EGG-SSDC-5381

March 1981

HUMAN FACTORS EVALUATION OF
THE ENGINEERING TEST REACTOR
CONTROL ROOM

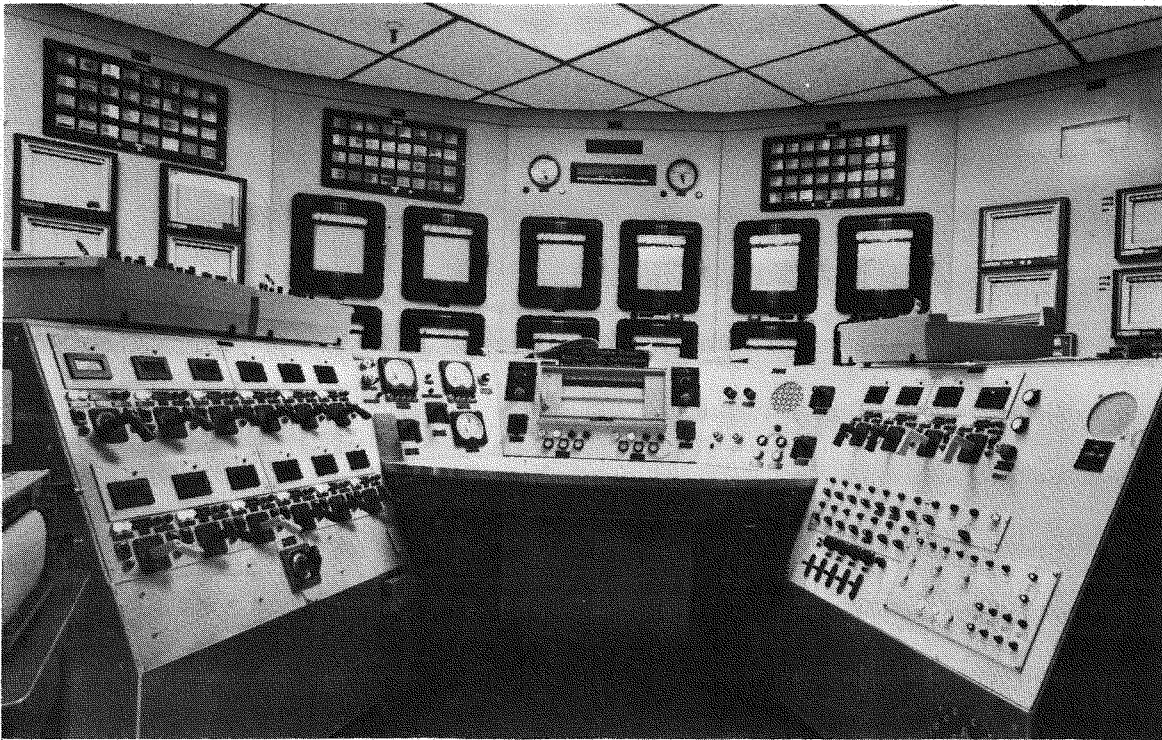
1. The shim rod withdrawal rotary select switch, located on the lower section of Panel R-11, functions to allow the shim rod to be withdrawn using the withdraw/insert switch on Panel R-13 (see Figure 1). Position feedback from the rotary switch is obtained by observing an unlabeled indicator light associated with each shim rod. It is difficult for an operator to determine quickly which shim rod is selected due to the placement of the selected indicator lights in an array of other similar-sized lights (high visual noise). Additionally, four of the rod select positions on the rotary switch are located on another panel 66 inches away (Panel R-15). It is recommended that the shim rod withdrawal control indicator lights and withdraw/insert switch be located in a functionally designated group. Another recommendation is to replace the rotary switch with lighted push buttons in a configuration that mimics the actual physical arrangement of the shim rods. The activated push buttons should

Figure 1. Reactor Console. 1) The shim rod insert withdraw/insert select switch, "A", is separated from the shim rod rotary-withdraw-switch, "B" by 38 inches. They should be grouped together. 2) The placement of the withdraw-selected lights, "C", in a field of similar lights makes them difficult to discriminate. 3) Shim-rod controls are separated into two groups on separate panels. They should be in one functional group.

1. The shim rods are grouped on two separate panels, R-15 and R-11 (see Figure 1). Rods 1-4 are on Panel R-15 and Rods 5-16 are located on Panel R-11. The control rods are classified into three separate groups--Group I, II, and III. Group III is further subdivided into three groups--IIIA, IIIB, and IIIC. All of Group I controls are used at the same time. However, the individual controls which comprise Group I are not placed together in a manner which makes it obvious that these controls are all Group I. Group II and III controls have the same grouping problem. The lack of grouping by function is a particular problem when attempting to maintain the Group III control rods to within 1 inch of each other. The current layout, grouping, and color-coding scheme is shown in Figure 8.

be back-lighted to indicate that a shim rod is available for withdrawal. If all the shim controls were placed on the same panel, and arranged by group, the push-button matrix could be designed similar to that shown in the table below. Additionally, the lighted push buttons should be color coded by group in a manner consistent with the shim groups. For example, BROWN could be used for Group 1, BLACK for Group 2, and GREY for Group 3.

It is recommended that all controls for the shim rods be placed on the same panel and that they be organized by functional group. A suggested layout is shown in Figure 9. The major feature of the layout is that all Group I, Group II, and Group III shim rods are respectively grouped together. Which rods are in which group, however, depends on the flux shape needs of the experiment and are subject to change from one experiment to another. It will be necessary to provide funds to change the behind-the-panel wiring in such a way that the functional groups are kept intact, regardless of the experimental flux requirements.

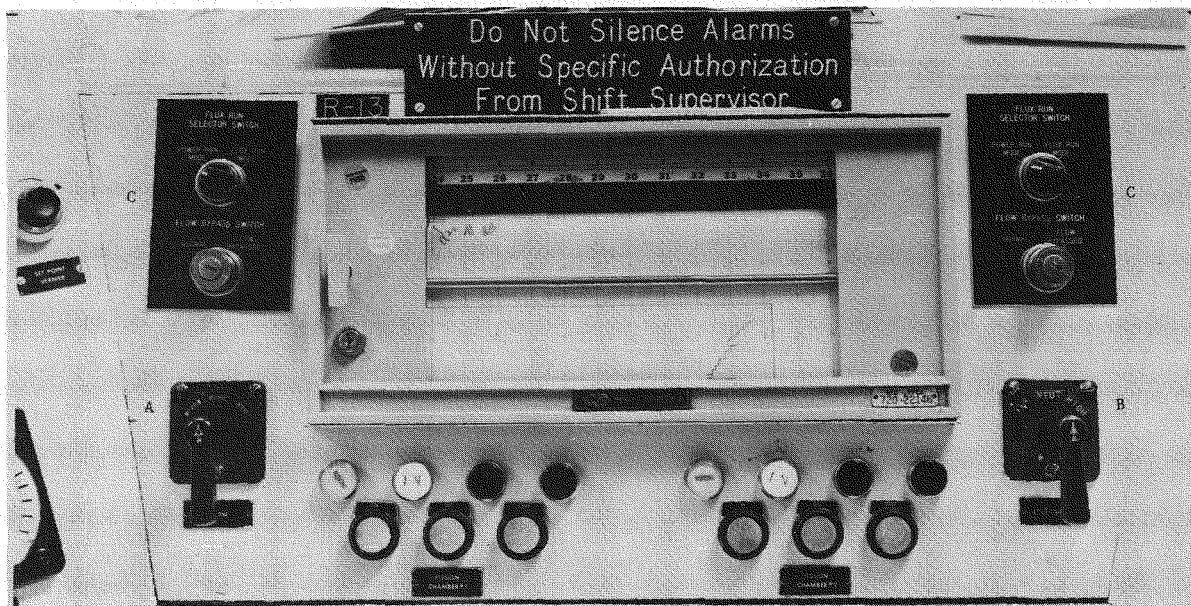
2. The movement relationship between the withdraw/insert switch and the intermediate/high withdraw switch causes some operator confusion (see Figure 2). The intermediate/high switch must be turned clockwise to withdraw the shim rods at high speed, while the withdraw/insert switch must be rotated counterclockwise to withdraw.

Figure 2. Panel R-13. A counterclockwise rotation of switch "A" causes the shim rod to withdraw. A clockwise or counterclockwise rotation of switch "B" causes the shim rod to withdraw. The flux-run selector switches, "C", are used only once prior to reactor start-up. The regulating rod position recorder uses only one pen at a time. The second pen could be used selectively to monitor one neutron level channel.

The two flux-run selector switches and flow-bypass selector switches located on Panel R-13 are normally used only once for "pre-positioning" prior to reactor start-up and are not used again for quite some time (see Figure 2). Because of this relatively low frequency of use, it is recommended that these controls be placed in a position removed from the operator's console. The operator's console should contain only controls with relatively high importance and/or frequency of use.

Normally, when using the intermediate/high withdraw switch, it is operated in the "high" position. A selector switch used in conjunction with the withdraw/insert switch to select single, intermediate, or high rates of withdrawal would be beneficial and eliminate the need for two separate pistol-grip switches. However, an engineering analysis is necessary to determine if a single switch can meet the single failure analysis criteria and if it can be used effectively in rapid power recoveries.

Figure 3. Panel R-12, R-7, and R-9. The water-power meter, "A" and the percent-pile-power meter "B", are used in conjunction with the flux-level set point switch "C", and the set point vernier, "D". These controls and displays should be grouped together.

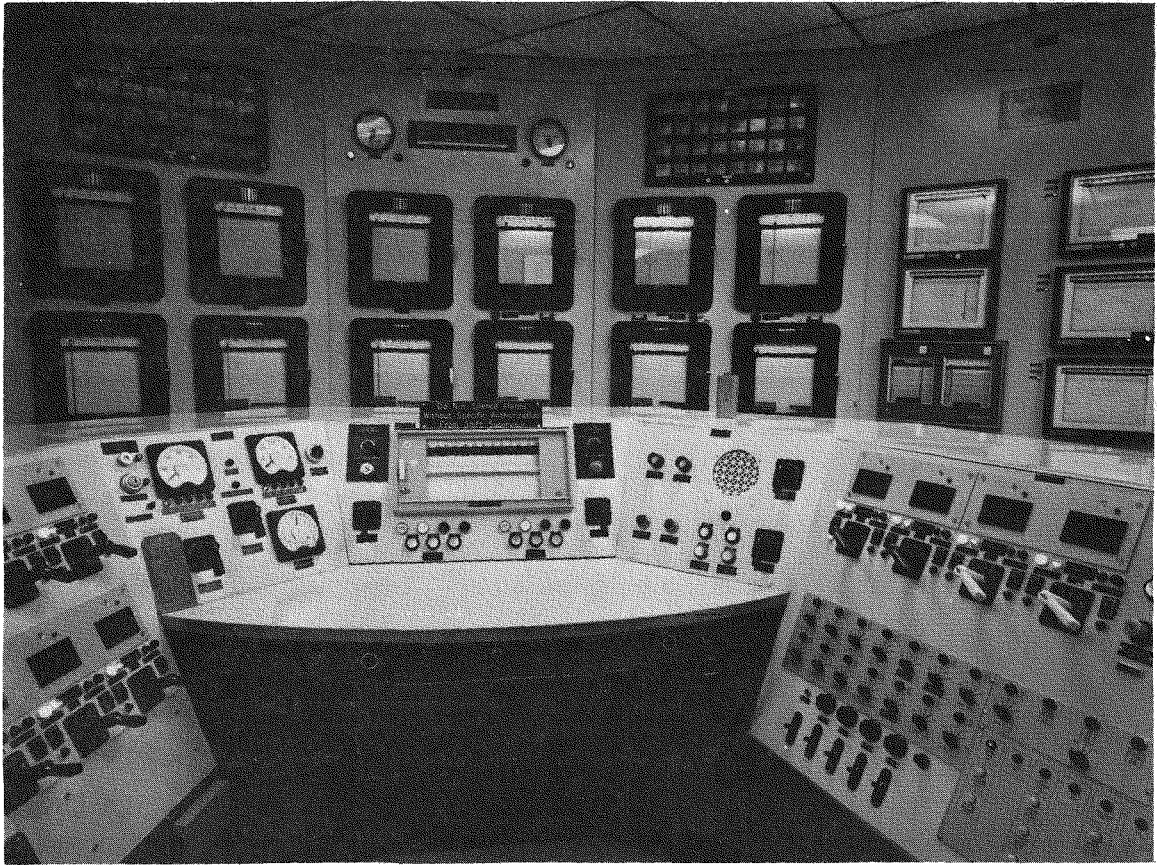
1. The flux-level set point and the vernier set point (both located on Panel R-12) function to control power. Two of the displays used in conjunction with above controls are the water-power meter (located on Panel R-9) and the percent-pile-power meter (located on Panel R-7). It is recommended that these controls and associated displays be located in a functional group together and bounded by demarcation lines (see Figure 3). The new servo system to be installed at ETR could incorporate these suggestions.

Figure 4. Emergency valve display indicator lights. The arrows are pointing to: (a) "open" indicator light, (b) "closed" indicator light, (c) "intermediate" indicator light. No information as to percent "open" or "closed" is given, nor is there any means to show the direction of valve travel.

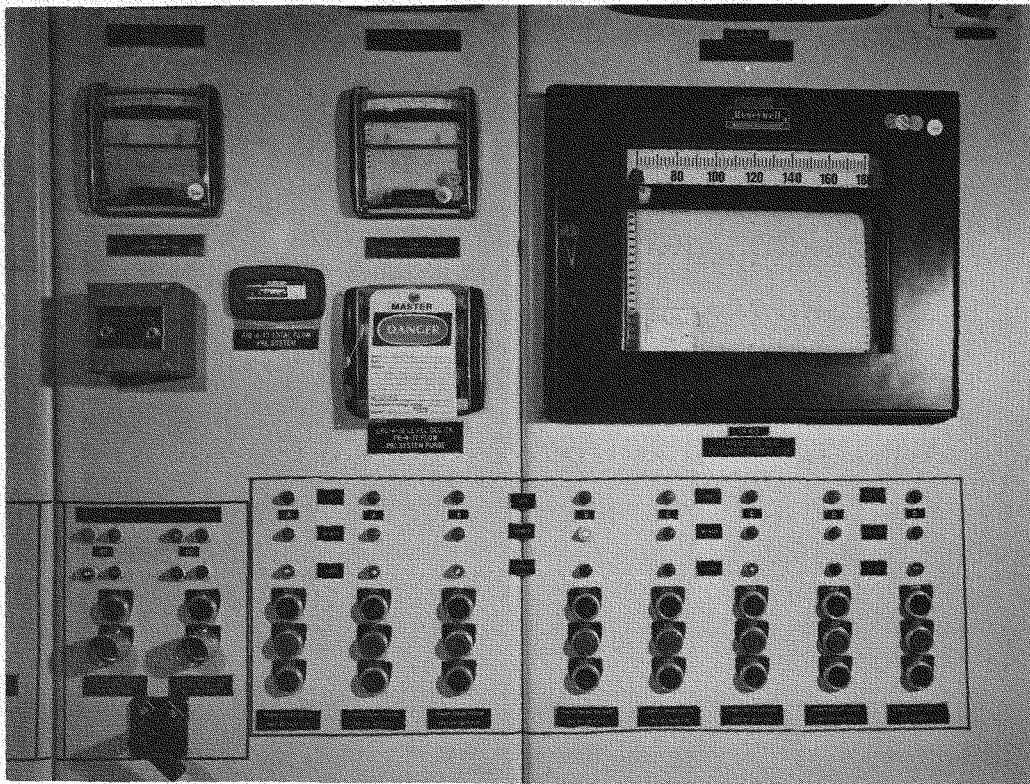
1. Emergency valve display indicator lights do not provide information to the operator regarding the percent any valve is open or closed (see Figure 4). The operator has only three indications: open, closed, and intermediate. This could be a particularly serious problem for flow-control valves. An operator does not know from console instruments the degree to which a valve is open or the direction it is traveling. In order to get this information, one must visually inspect the valves which are outside the control room (see Figure 5). It would be advantageous if this information were displayed directly to the operator on the control console. This could be accomplished through a synchro-servo system run directly from the valve into the control room.

Figure 7. MG-1 Speed Control Panel (Arrow) scale range is inadequate and distance from other associated controls, too far.

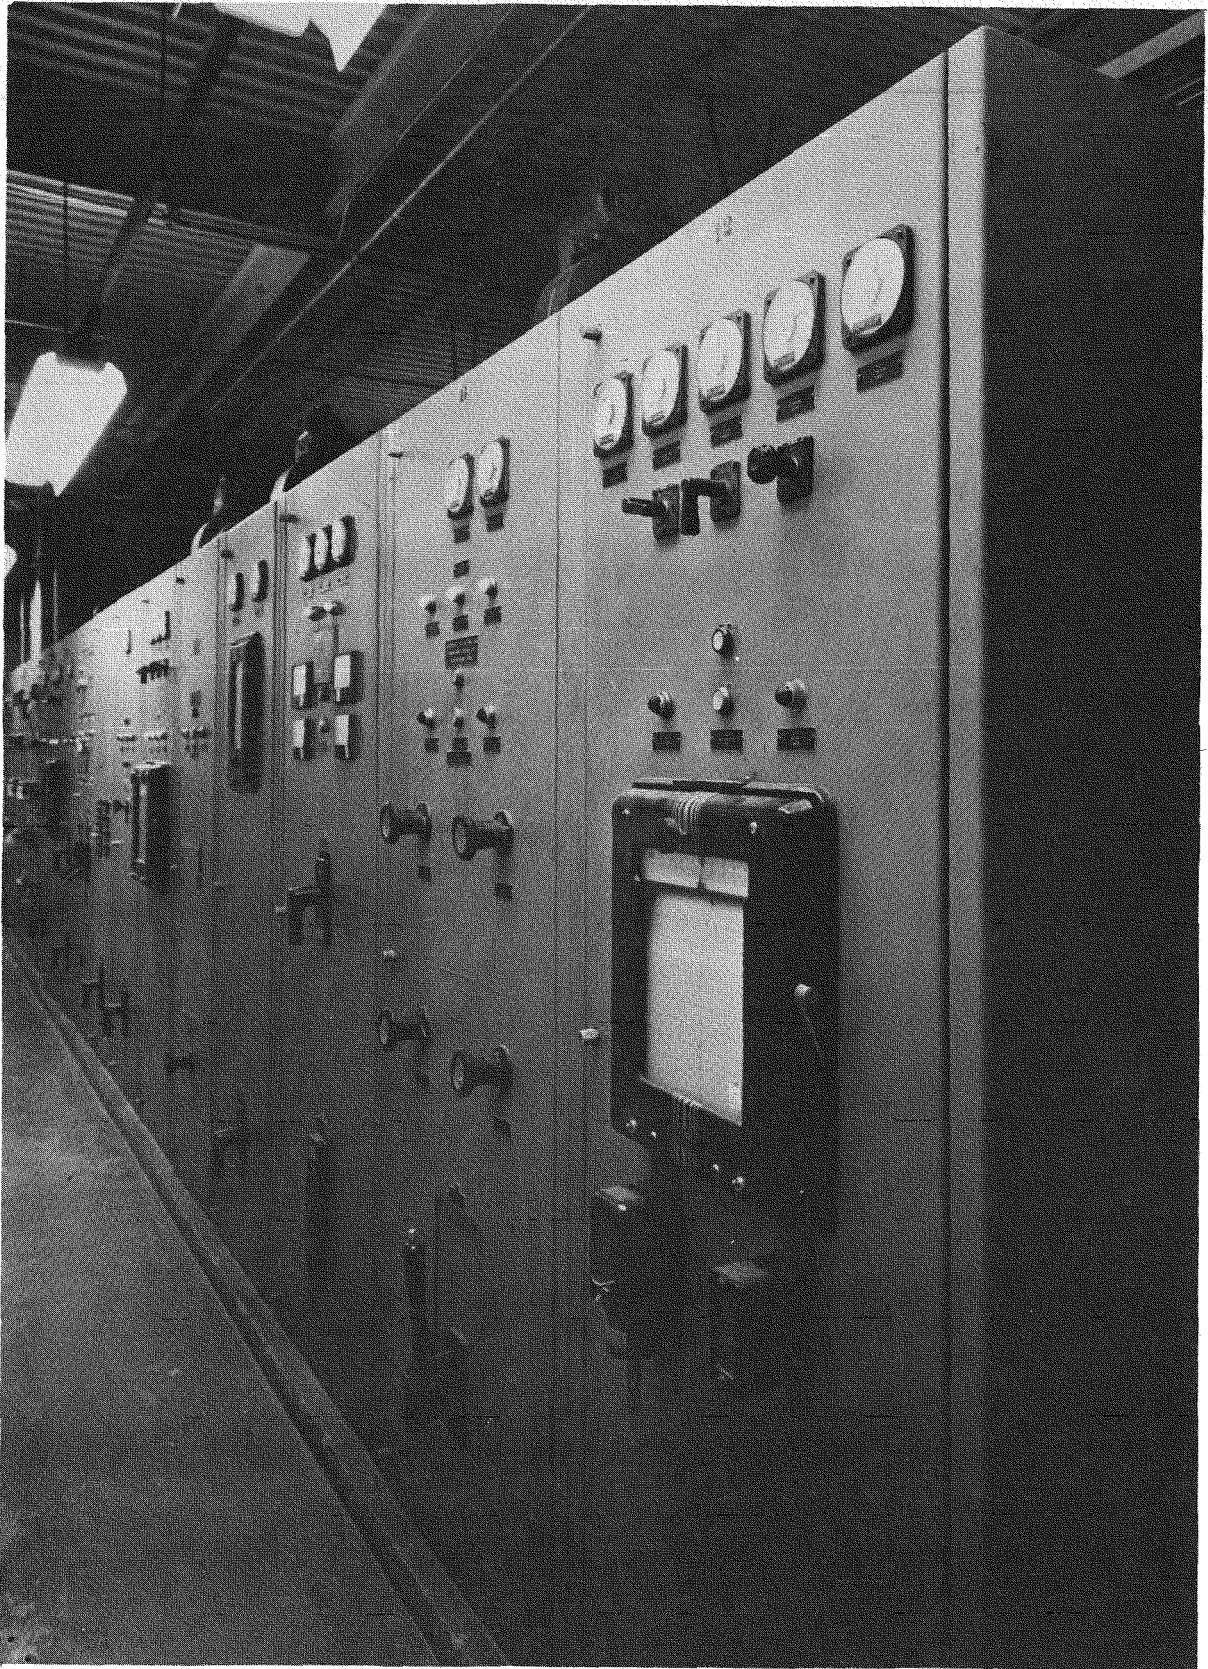
3. The MG 1 Speed Control Panels and the MG 1 Main AC Machine current panel oftentimes must be accessed concurrently but are separated by over 50 feet (see Figure 7). By combining the controls and meters necessary to operate the system on one console, or providing duplicate meters, this problem would be eliminated.

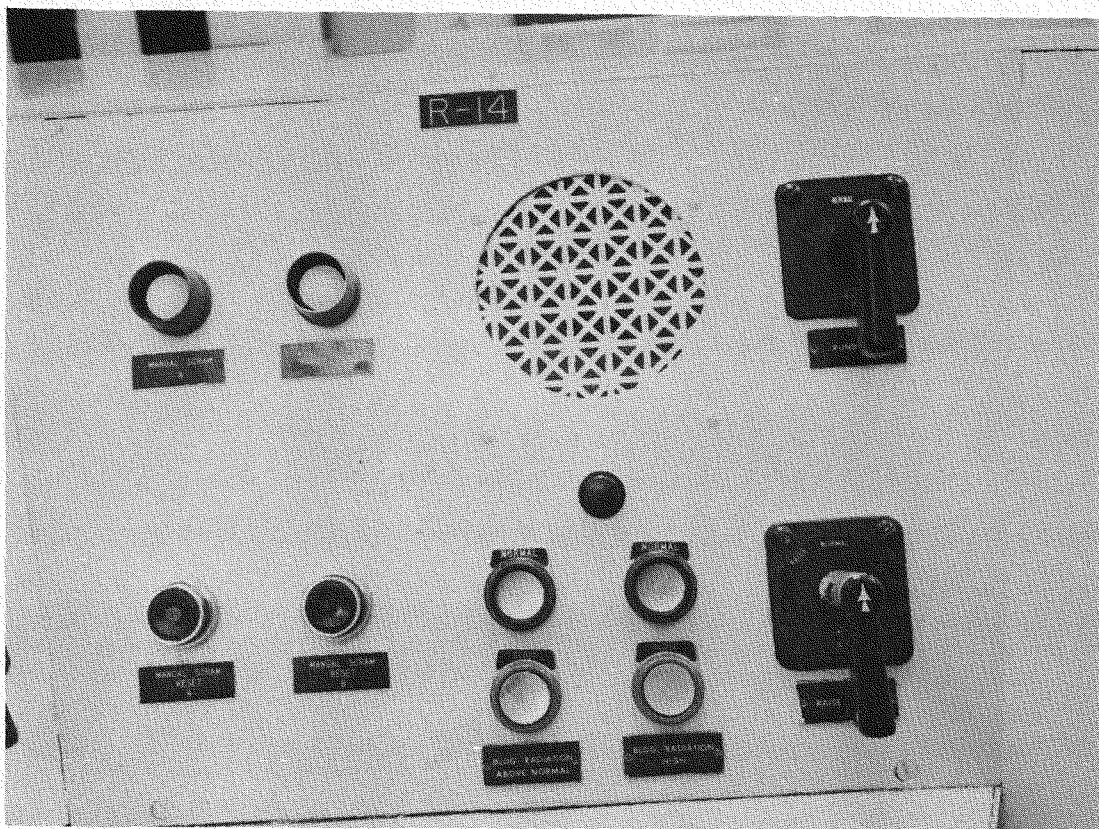
2. The shim rod "raise-normal" switch located on Panel R-14 is used normally during shutdown for maintainance purposes only (see Figure 10). It is recommended that Panel R-14, because of its optimal visual position (within the operator's best field of view), be used only for those controls or displays which are used most frequently or are considered to be most important to reactor operation. The raise switch is not as important as other controls and, therefore, should be moved to a position of lower visual prominence.

The two manual reactor shutdown controls, the Manual Scram push button (Channel A and B) and the Manual Rundown pistol-grip switch are located on Panel R-14 (see Figure 10). The current reactor control circuitry is such that the initiation of either will cause a shutdown of the reactor. Both manual scram switches are protected by raised rings; however, the manual rundown switch is a pistol-grip control identical in size and shape to 21 other controls on the reactor console. It is recommended that the rundown activation switch be treated and protected in the same manner as the manual scram controls. Additionally, it is recommended that some form of protection be used to protect all emergency reactor shutdown controls from inadvertent activation. This protection should not interfere with intentional activation.

Figure 10. Panel R-14. 1) The raise-normal switch, "A", is used for maintenance only and should be in a less prominent position. 2) The manual rundown switch, "B", is not protected from accidental activation. 3) The Building air-seal switches, "C", are emergency control switches not used during normal reactor operation and should be functionally grouped with all other emergency controls. 4) The intercom volume control switch, "D", is not labeled.

5. The four building seal controls located on Panel R-14 are used only in the event of an emergency and not during normal plant operation (see Figure 10). It is recommended that these controls be removed from the reactor console and functionally grouped with other emergency instruments, e.g., the Evacuation Alert Panel. It is recommended that indicators be provided to indicate which controls have been activated.

Figure 11. Emergency Controls on Panel R-1. All of these controls are located about 80 inches from the floor. They should be repositioned to be within the reach envelop of each operator.

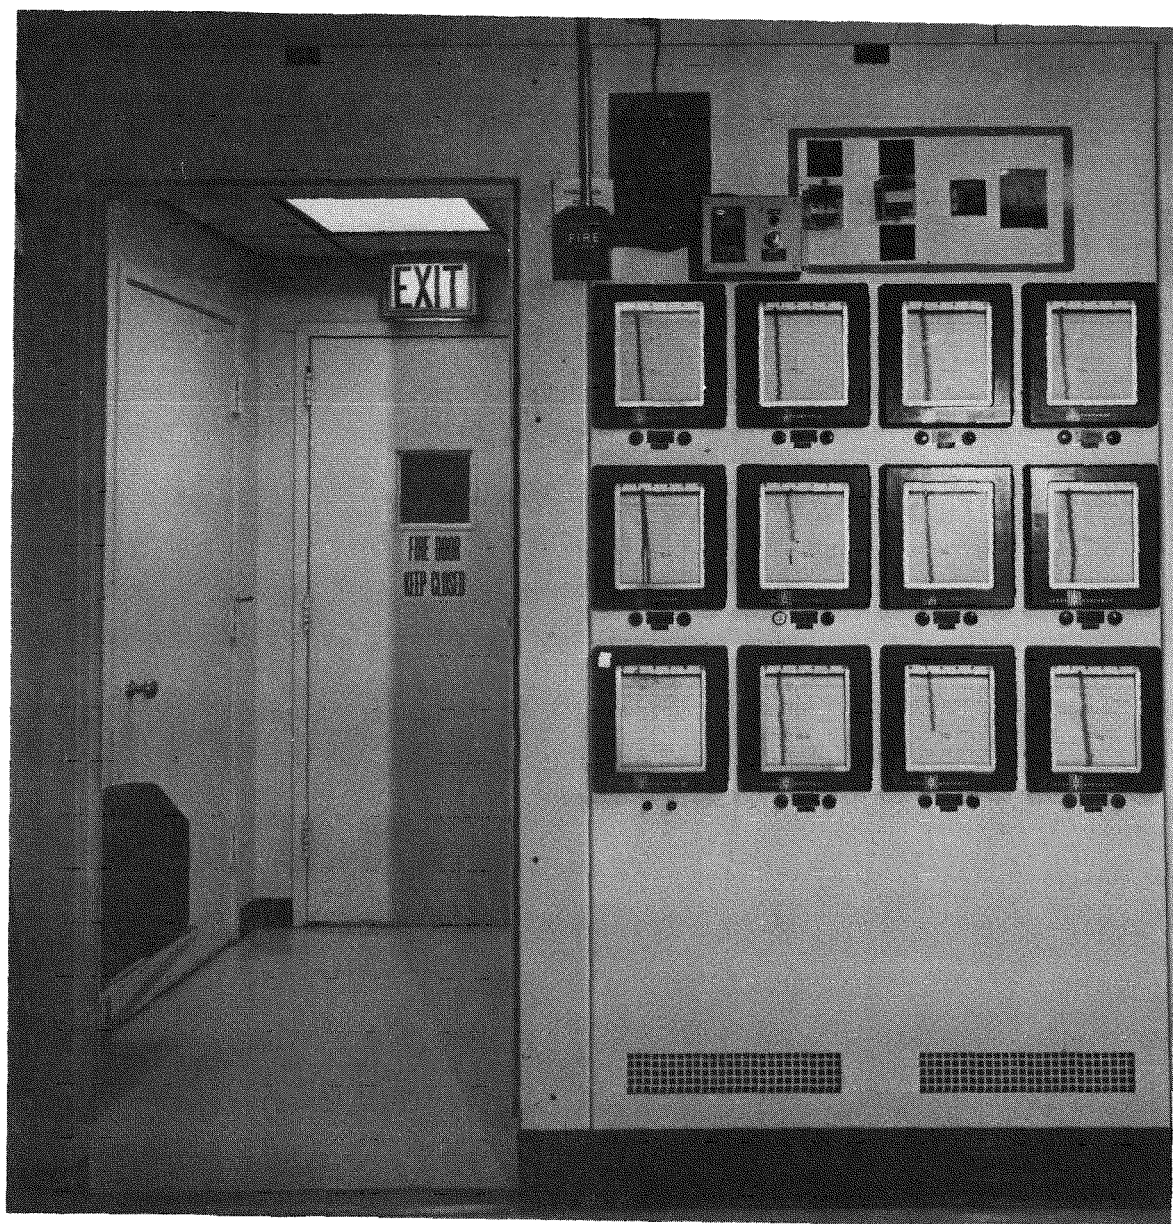
1. The emergency evacuation controls on Panel R-2 are located 83-inches high, measured from the floor (see Figure 11). Personnel shorter than 5 ft 5 in. would require some elevation aid to assist them in operating these controls. It is recommended that these controls be repositioned within the reach envelop of the shortest person required to operate this system. More specifically, controls should be situated where the 5th percentile (height) operator can easily reach them. Relocation of these controls could be performed when the new continuous air-monitoring system is installed.

7. In the case of accidental activation of the Halon Fire Suppression System, the present manual inhibit switch must be depressed continuously

until a key can be obtained to deactivate the control circuitry (see Figure 11). The height of this control (6 ft 7 in.) precludes people shorter than 5 ft 2 in. from reaching it. Additionally, the current control height could cause rapid hand/arm fatigue for these people, if they were required to continually depress the inhibit switch. It is suggested that this device be lowered to accommodate the shortest operators reach envelope (70 inches from floor). In addition, it might save time in an emergency if the reset key was suspended nearby via 5-pound safety wire so that the key could be easily located and used when needed. Another suggestion related to the Halon Fire Suppression Button would be to employ an activation device that need only be depressed once to inhibit the system instead of requiring continuous^a control depression.
